Access Compliance Report

Public Rights-of-Way

Intersection ID: 54373	Main Street: BENSEVAL_LN	Cross Street: ARNOTT_LN	Location: E
ADA ID: 6BBA70CF047A	Ramp Type: PerpDiag	Initial Pass/Fail: Fail	Overall Compliance: No
Codes/Mitigation Info/Possible Solution		Field Measurements/Component Compliance

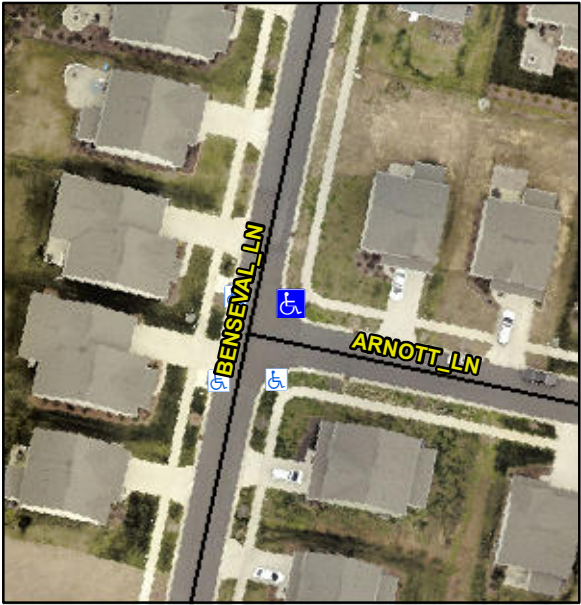
Possible Solutions:	Compliance	Description	Data	Compliance	Description	Data
	Remove & Replace Curb Ramp With Two New Directional Ramps or Equivalent.	N/A	Ramp Length (in)	110.0	No	Ramp Slope (%)	8.6
<p>Surveyor Notes:</p> <p>N/A</p> <p>PROW/ADA:</p> <p>Not Found, R304.2.2, R304.5.3</p>		Yes	Ramp Width (in)	48.0	No	Ramp XSlope (%)	4.7
		N/A	Flare Type LT	N/A	N/A	Flare Type RT	N/A
		N/A	Flare Slope LT (%)	N/A	N/A	Flare Slope RT (%)	N/A
		N/A	Flare Traversable LT?	N/A	N/A	Flare Traversable RT?	N/A
		N/A	Landing Length (in)	N/A	N/A	DWS Provided?	N/A
		N/A	Landing Width (in)	N/A	N/A	DWS Contrast?	N/A
		N/A	Landing Slope (%)	N/A	N/A	DWS Length (in)	N/A
		N/A	Landing X Slope (%)	N/A	N/A	DWS Full Width?	N/A
		N/A	Landing Curb? (Y/N)	N/A	N/A	DWS Offset (in)	N/A
		N/A	Shared Landing?	N/A			
		N/A	Gutter Ponding?	N/A	N/A	Gutter Slope (%)	N/A
		N/A	Gutter Lip Ht (in)	N/A	N/A	Gutter X Slope (%)	N/A
		N/A	Painted X Walk1?	No	N/A	Painted X Walk2?	No

X Walk 1 Direction	To NW		X Walk 2 Direction	To SW
		N/A	X Walk 1 Width (in)	N/A	N/A	X Walk 2 Width (in)	N/A
			X Walk 1 Slope (%)	2.9		X Walk 2 Slope (%)	0.6
			X Walk 1 X Slope (%)	3.2		X Walk 2 X Slope (%)	1.4
		N/A	Ramp inside XWalk1?	N/A	N/A	Ramp inside XWalk2?	N/A
			Road Slope (%)	4.0	N/A	Clear Space?	N/A
			Road X Slope (%)	2.0	N/A	Clear Space to XWalk (in)	N/A
		N/A	Any Obstructions?	N/A	N/A	Storm Grate/Utility Hazard?	N/A
			Obstruction Type			Storm Grate/Utility Type	
					N/A		N/A
					Yes	Surface Condition? (G/P)	Good
